SUBJECT: Coastside Design Review Continuation
Cortez Avenue, Miramar
APN 048-032-070; County File No. PLN 2018-00397

At its meeting of May 9, 2019, the San Mateo County Coastside Design Review Committee (CDRC) considered your design review application to allow construction of a new 1,732 sq. ft., two-story single-family residence, plus a 380 sq. ft. two-car attached garage, located on an existing 4,400 sq. ft. legal non-conforming parcel (legality confirmed via PLN2014-00116), as part of a hearing-level Coastal Development Permit (CDP) and a Non-Conforming Use Permit (UP). The UP is required to allow development on a non-conforming parcel with proposed right and left side setbacks of seven (7) feet each, where ten (10) feet is the minimum allowed for each side. No trees are proposed for removal. The CDRC was unable to make the findings for design review recommendation of approval based on certain design deficiencies. In order to resolve these deficiencies in the project's design, a more thorough review of the "Standards for Design for One-Family and Two-Family Residential Development in the Midcoast" manual is required, with emphasis on Section 6565.20(C)2. Complement Other Struct

LANDSCAPING Plan
 Designed by Leslie B. Wagle

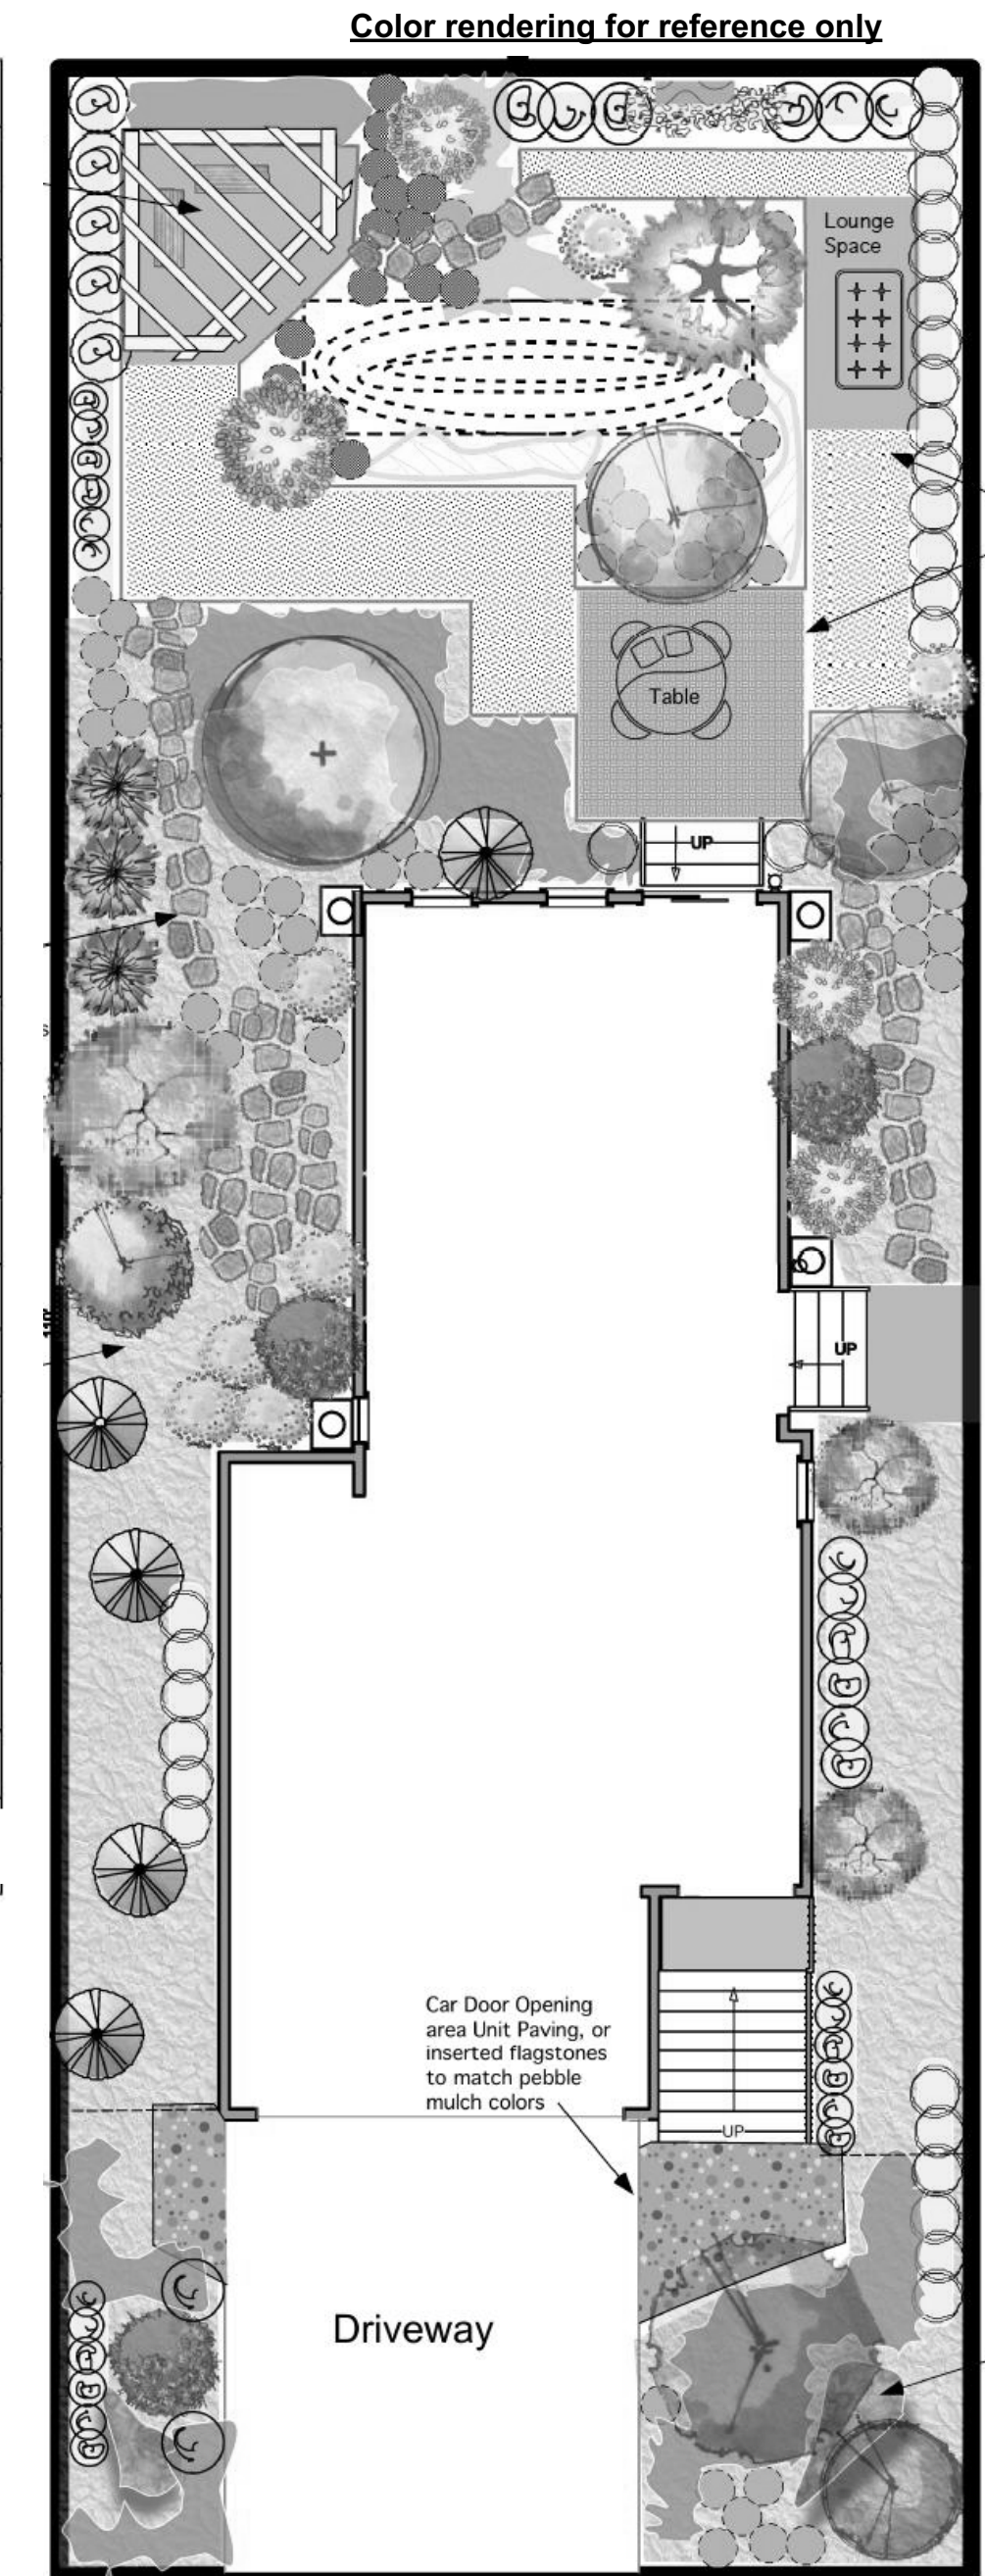
Group plantings for a more natural effect.

Reduce grass area significantly.

14. Landscape is now redone by a Landscape architect. We went over and make it really nice landscaping design. Groups of plants now introduce in the plan.
Redesign: Landscape is now redone by a Landscape architect. We went over and make it really nice landscaping design. Groups of plants now introduce in the plan.
15. Incorporate a tree/plant species, plants that grow to a more substantial height and have longevity in a coastal zone, in the landscape plan. Roses are not recommended.
Redesign: Landscape design is now done by landscape Architect. Adding tens of new plants to the plan by Landscape architect. Roses removed.
16. Replace and reduce concrete paving throughout the project. Replace with pervious material.
Redesign: No concrete anywhere...all Permeable pavers now.

17. Grass removed from the plans. Landscape design is now redone by a Landscape architect.

Elevations

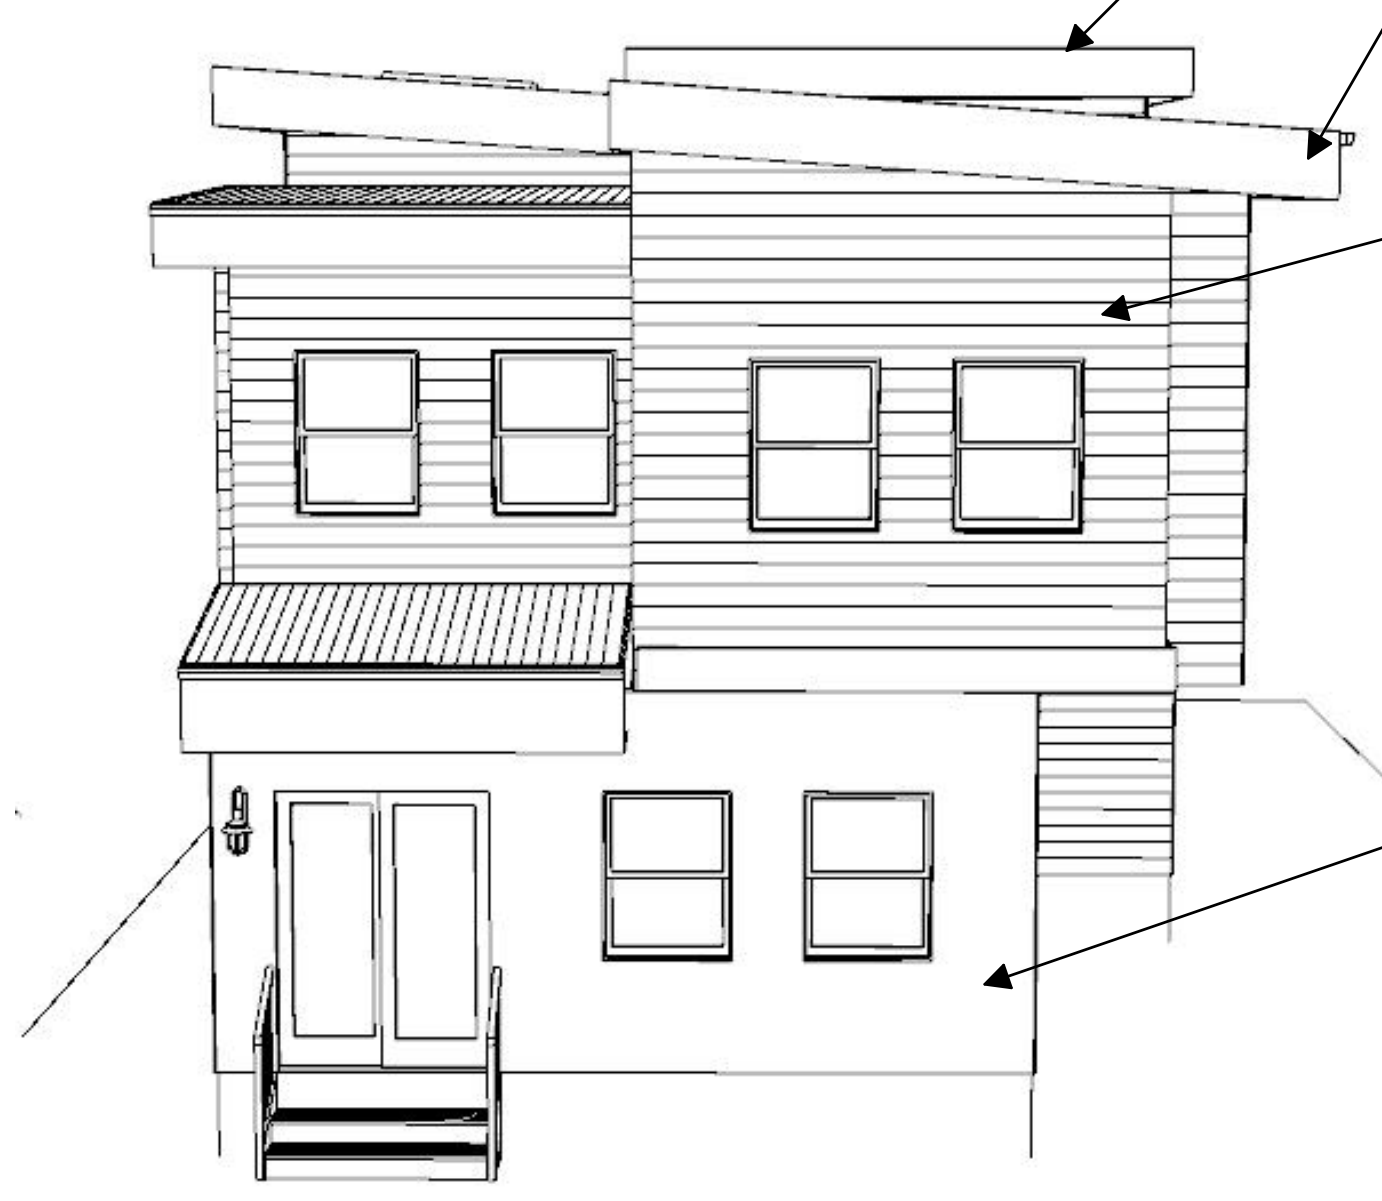
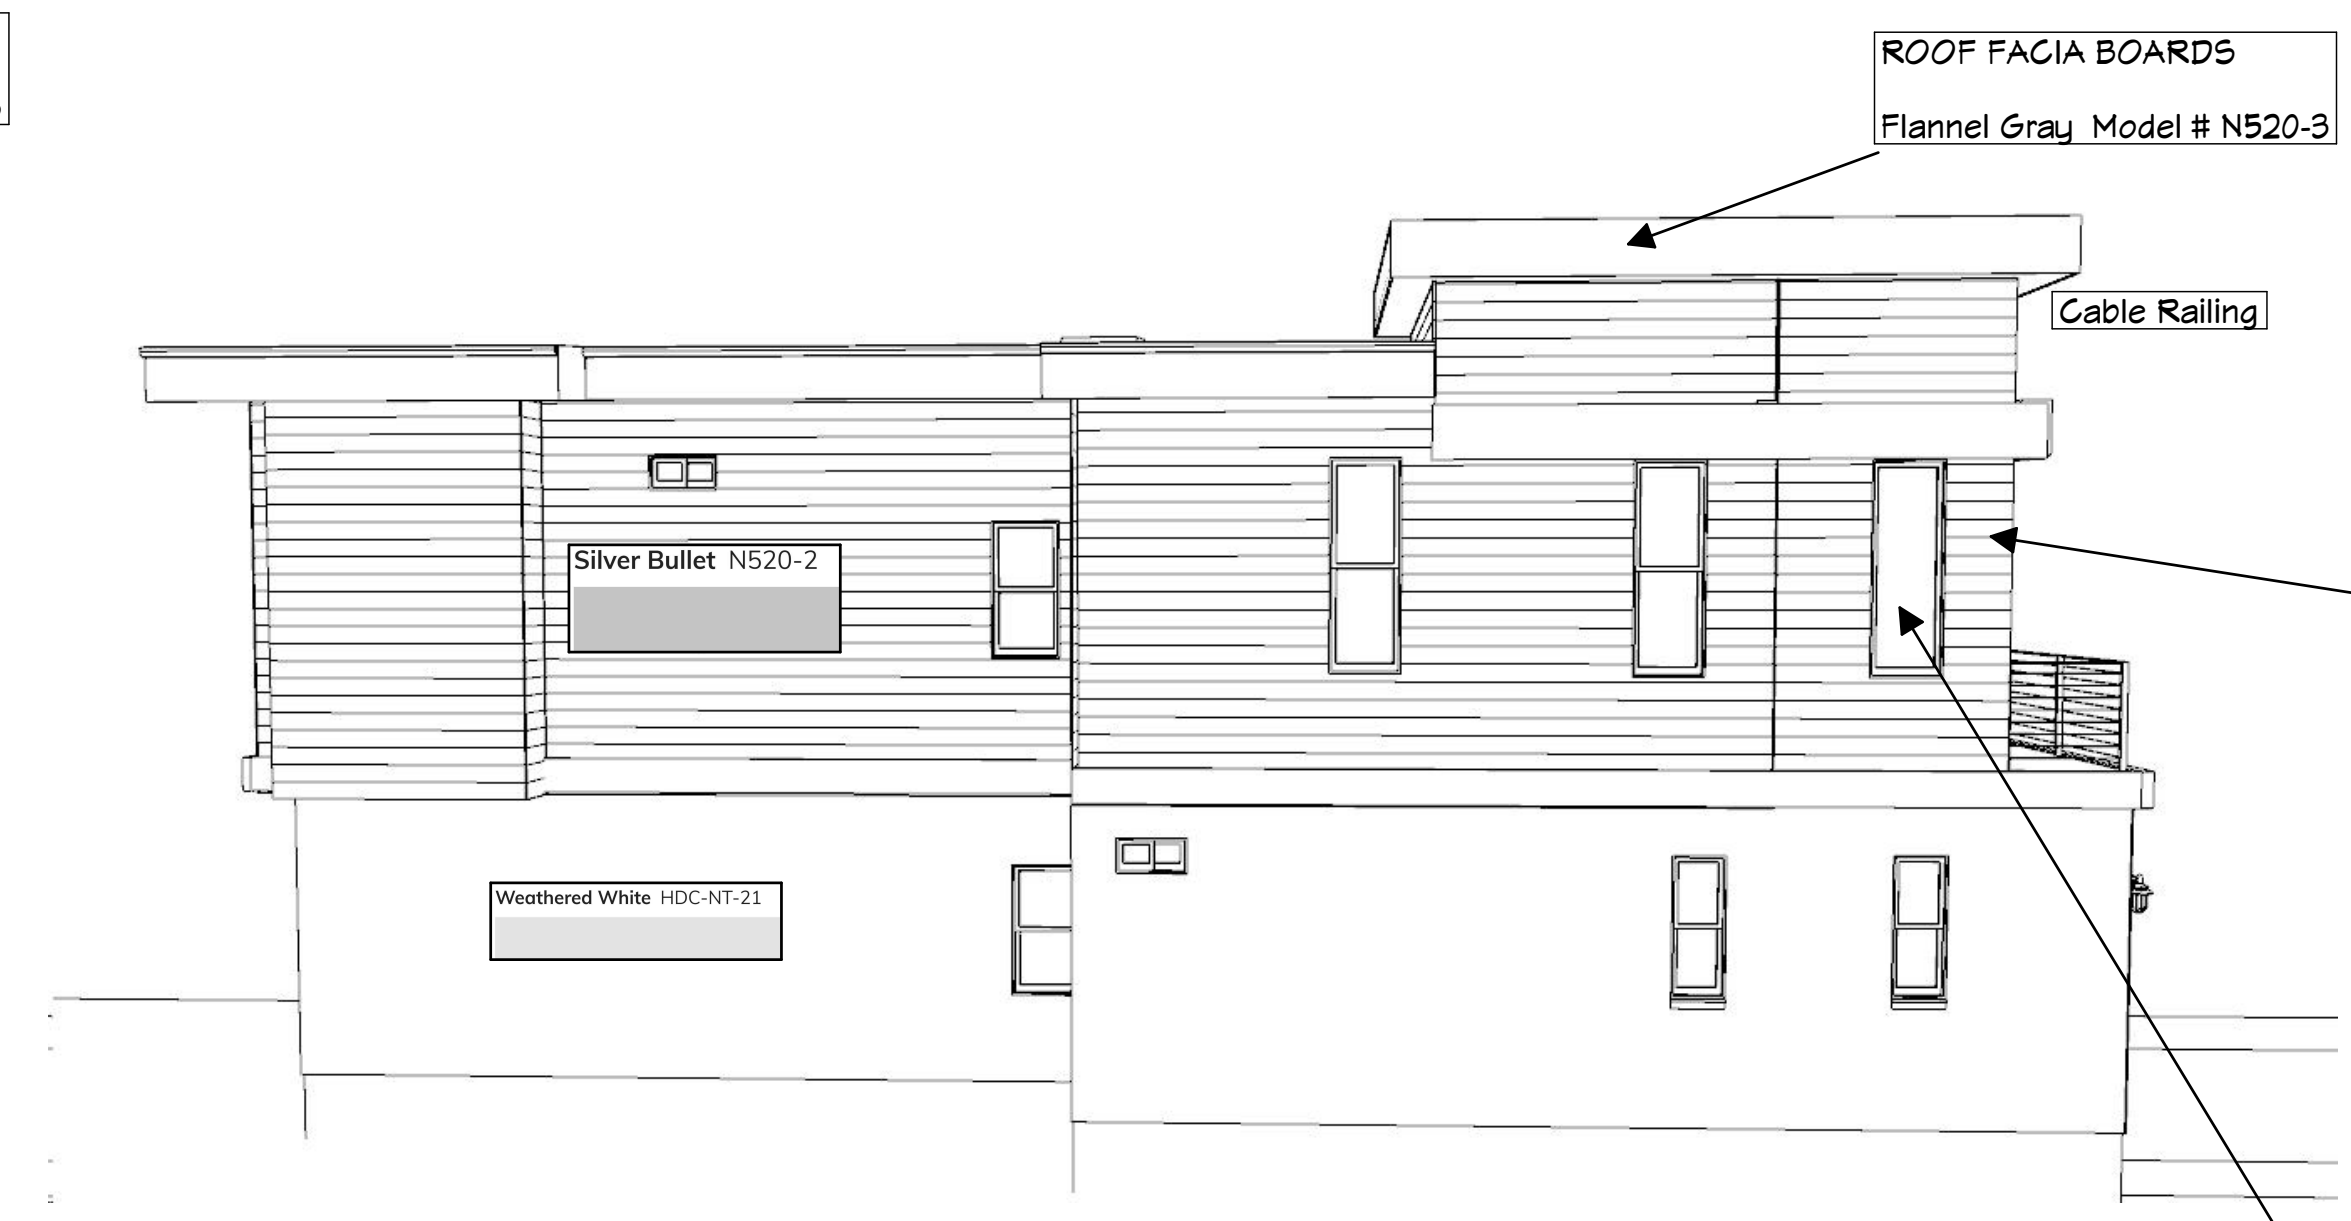
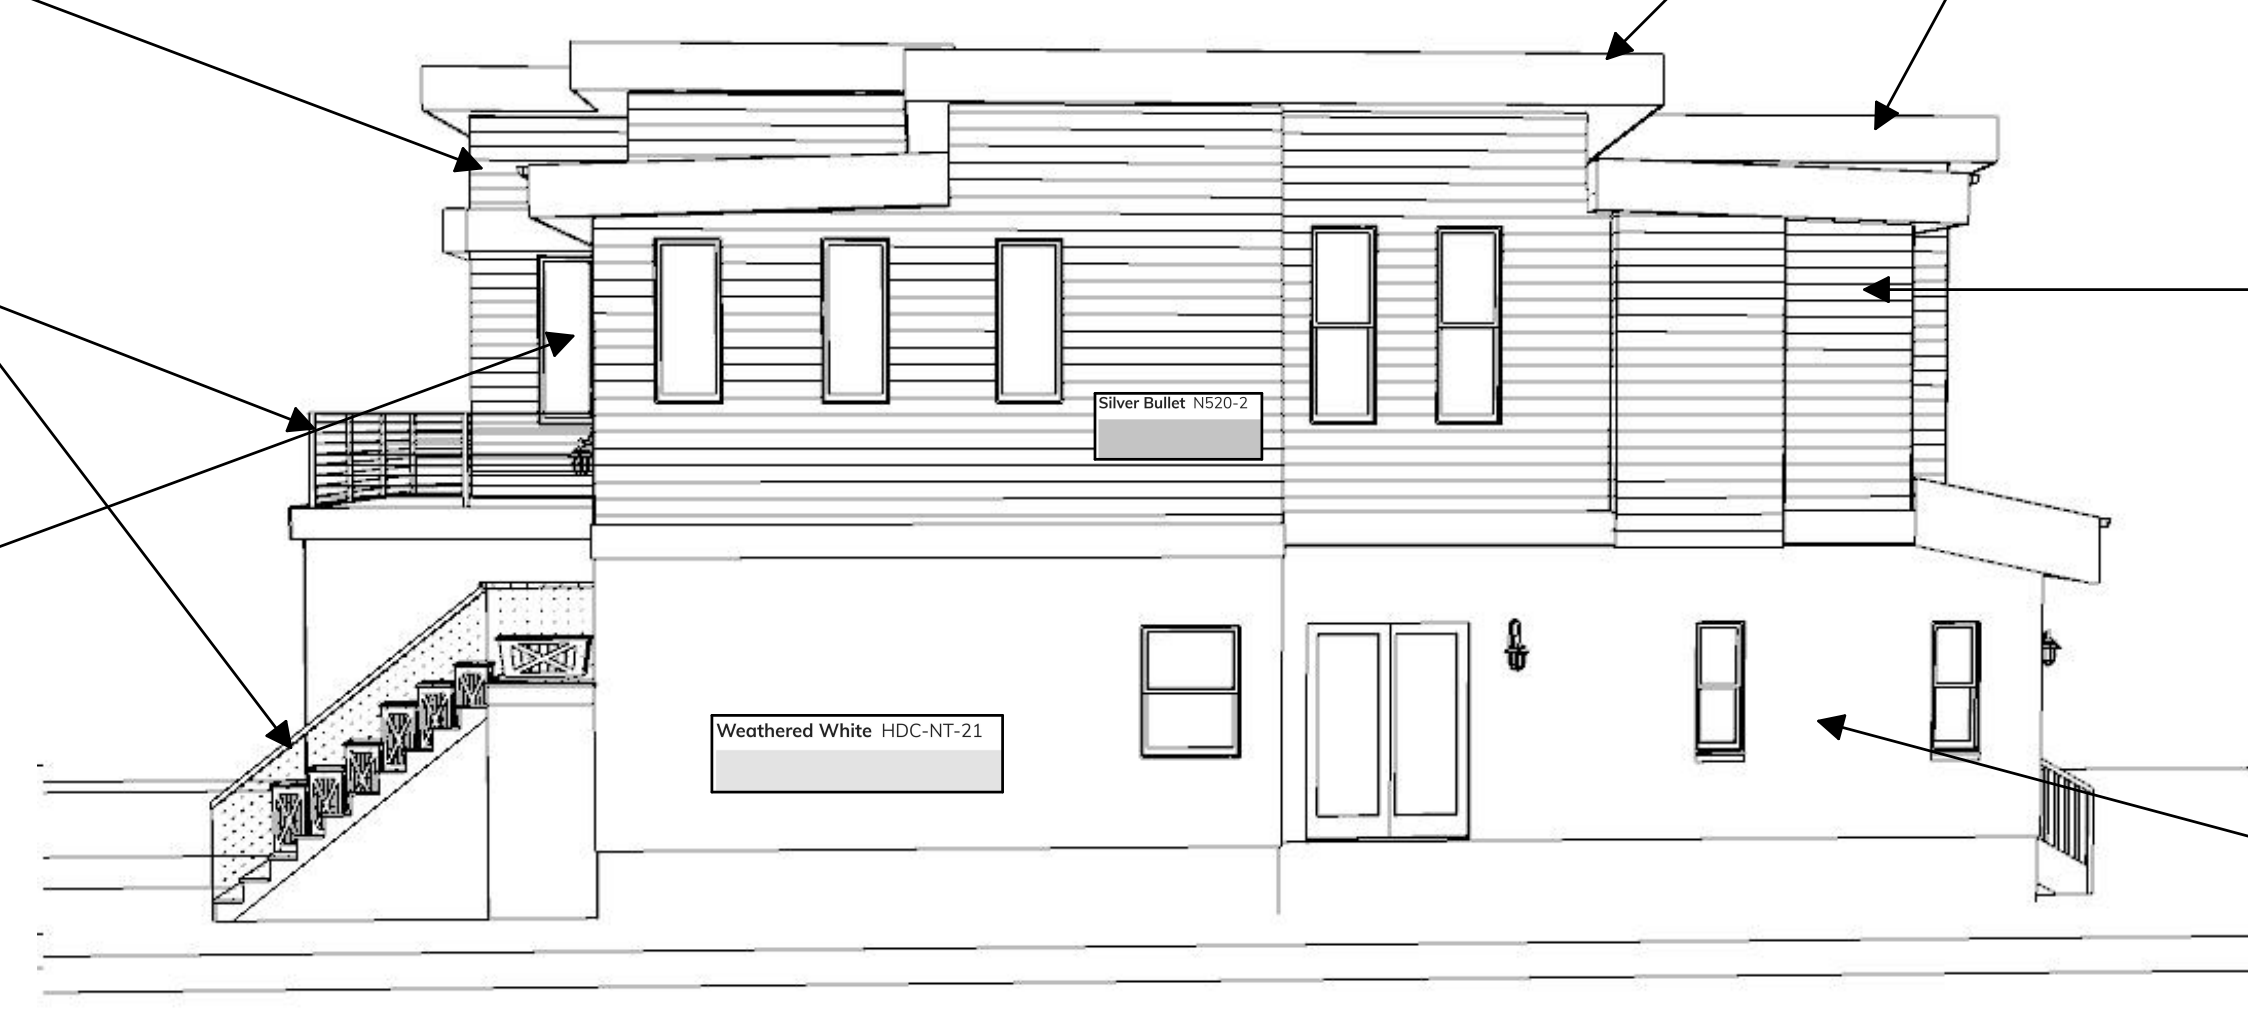
1. Add a step up from garage into house.
2. If contemporary massing is intended, select a color palette more compatible with the predominantly pastel/earth-tone palette in the neighborhood. Consider overall composition for the color and materials. The current proposed palette is very busy with too many colors and materials in locations that do not create cohesive design.

3. Reduce the height of vertical wall sections to modulate the roof form to add roof articulation.
4. Provide greater roof and wall articulation to mitigate the boxy form of the residence per Section 6565.20(D) Elements of Design 1.c, Second Stories.

8. Consider eliminating the roof deck to ensure neighbor's privacy.
9. Vertical proportions on the right side of the residence need to be addressed along with the ones on the front facade.

Soft color Pallet
